AMENDMENT NO. 2 AUGUST 2017
TO
IS 13702 : 1993 PROPYLENE GLYCOL, FOOD GRADE — SPECIFICATION

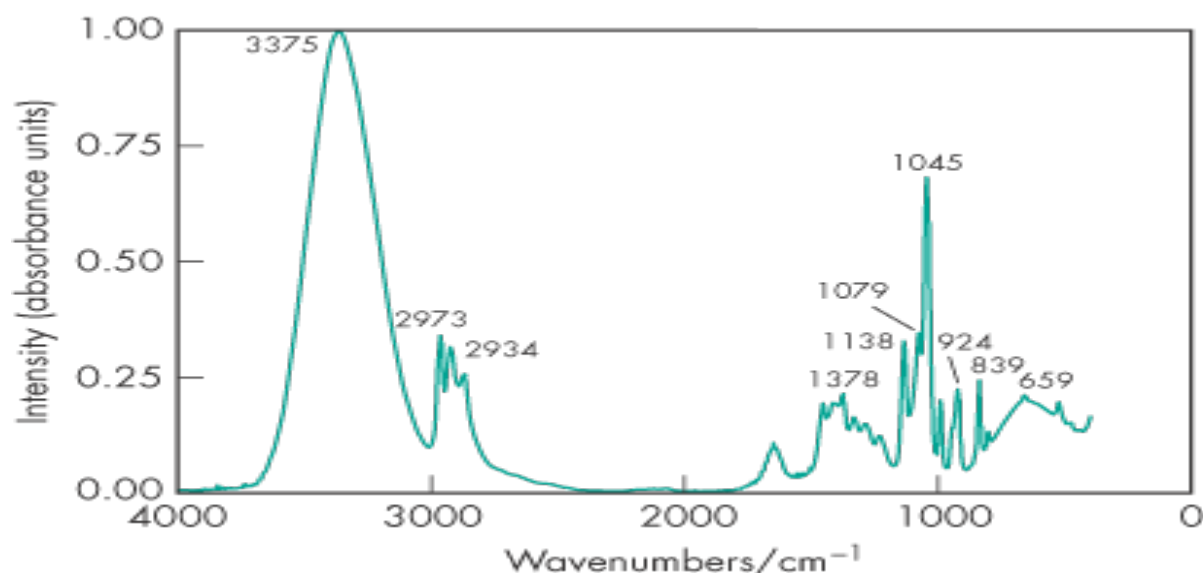
(Page 1, *clause 3.2.2*) — Insert the following new clause at the end:

‘3.2.3 The infrared spectrum of a potassium bromide dispersion of the sample corresponds with the infrared spectrum below:
